## Adding a Second ACD HVBS to Each FREE Board

Figure 1 shows the measured efficiency for two different flight-like tiles, as a function of threshold, with only one PMT per tile operating (colored curves), and with both PMT's on a tile operating (black curves).

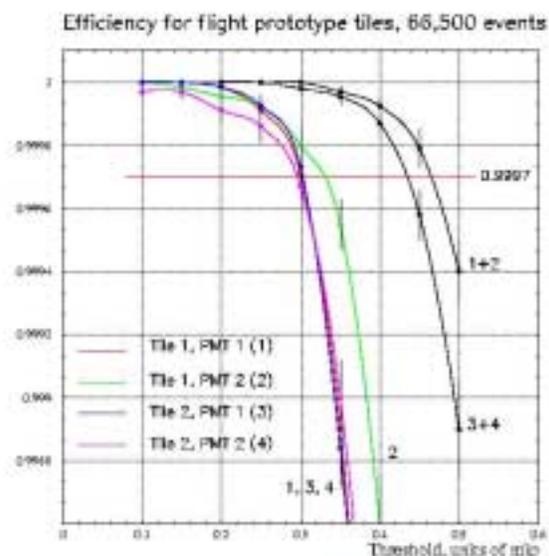
Figure 1 seems to indicate that the required efficiency (0.9997, the horizontal brown line) is met, at the nominal detection threshold of 0.3 MIP, with only one PMT per tile. Note, however, that there is no margin at all for three of the four PMT's used. Additionally, for these measurements no clear-fiber extenders were used. Although no tests have yet been done with the clear-fiber extenders, it is anticipated that the wave-shifting-fiber-to-clear-fiber connectors could cause a light loss of as much as 15%. (The clear fibers themselves should have essentially no loss.) Calculation of the effect of a 15% reduction in signal (light loss) shows that it will lead to a significant decrease in the tile efficiency. For single-PMT operation, the tile efficiency is expected to be about 0.9990, well below the

required 0.9997.

Since each HVBS powers the PMT's for 14-16 tiles, failure of a HVBS therefore reduces the efficiency for 14-16 tiles to  $\sim 0.9990$ . This is considered to be unacceptable, and thus the HVBS is considered to be a potential for single-point failure.

Based on potential failure criteria changes and their corresponding impact on the mission success, it is recommended that (stand-by) redundant High Voltage Bias Supplies (HVBS's) be added to each of the 12 ACD Front-End Electronics (FREE) circuit cards.

The addition of (stand-by) redundant HVBS's eliminates the potential *single-point* failure mode.
